UNITED STATES PATENT AND TRADEMARK OFFICE

APPLICATION NO.	FILING DATE	FIRST NAMED INVENTOR	ATTORNEY DOCKET NO.	CONFIRMATION NO.
10/520,541	01/04/2005	Alain Virgl	15675P566	9359

Office Action Summary	Application No. 10/520,541	Applicant(s) VIRGL ET AL.	
	Examiner Katherine W. Mitchell	Art Unit 3677

DETAILED ACTION

FIG. 3

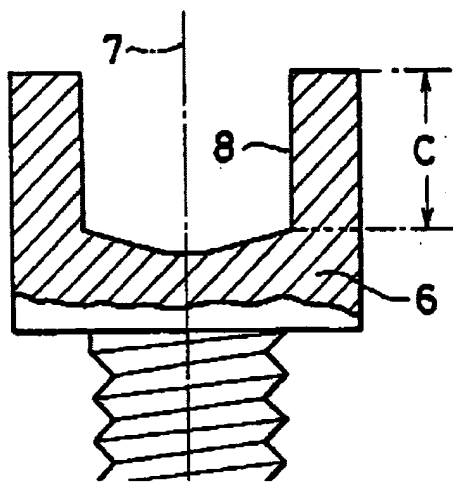
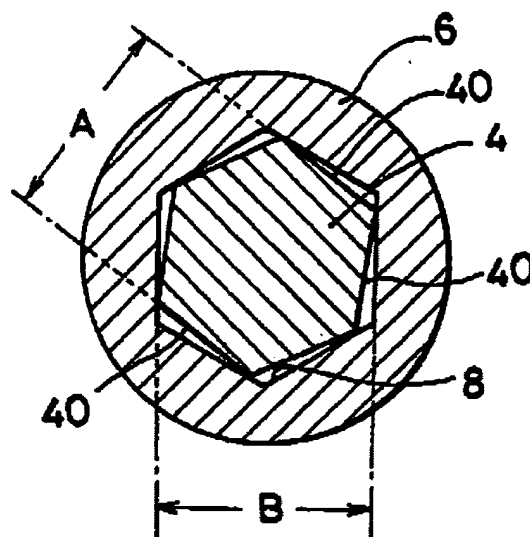
RE claims 1-2: '021 teaches in Figs 3 and 4 a hollow socket head fastener with a depth greater than 0.6 times a diameter of the socket, but is silent on the steel and carbon content of the metal. ASM teaches that "grade 1022 steel is a popular low-carbon steel for threaded fasteners" on page 7 of 17. Examiner takes Official Notice that Grade 1022 steel is defined as having 0.17-0.23% Carbon. Note that this a product claim, and the method of forming the device is not germane to the issue of patentability of the device itself. Therefore, it would have been obvious to one of ordinary skill in the

Re claim 3: '021 specifies that the depth "C" (which examiner notes does not include the depth of the bottom angled recess) is at least 60%.

Re claim 3: A deeper socket of 0.8 or more of the socket diameter would be obvious to one of ordinary skill in the art, if the socket needed to span a deeper hole in a substrate or allow for deeper/longer engagement with the driving tool. Such proportions are within bolt head standards. Further, examiner notes that applicant did not specify a particular diameter, and clearly '021 has a socket diameter that approaches zero, where the angled bottom of the socket tapers to a point.

FIG. 3

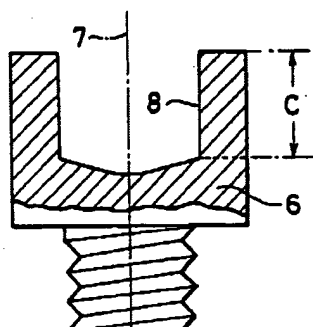
RE claims 1-2: '021 teaches in Figs 3 and 4 a hollow socket head fastener with a

depth greater than 0.6 times a diameter of the socket, but is silent on the steel and carbon content of the metal. Cassidy teaches that a low carbon steel for threaded fasteners" on pages 3-4, per below:.

Re claim 3: '021 specifies that the depth "C" (which examiner notes does not include the depth of the bottom angled recess) is at least 60%.

A deeper socket of 0.8 or more of the socket diameter would be obvious to one of ordinary skill in the art, if the socket needed to span a deeper hole in a substrate or allow for deeper/longer engagement with the driving tool. Such proportions are within bolt head standards. Further, examiner notes that applicant did not specify a particular diameter, and clearly '021 has a socket diameter that approaches zero, where the angled bottom of the socket tapers to a point.

**Fig. 2****Response to Arguments**

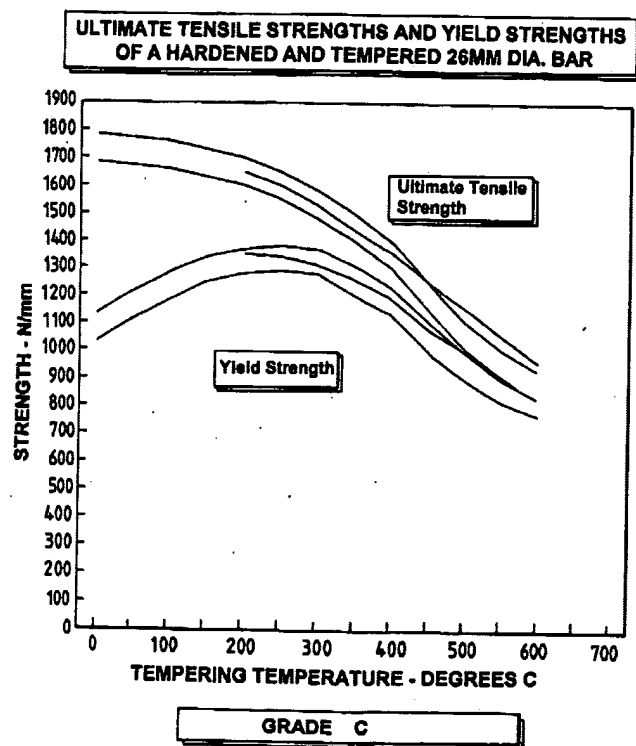
Re claim 11: Minimum tensile and yield strengths as claimed are taught in Fig 2 below, noting Mpa = N/mm Strength of graph.
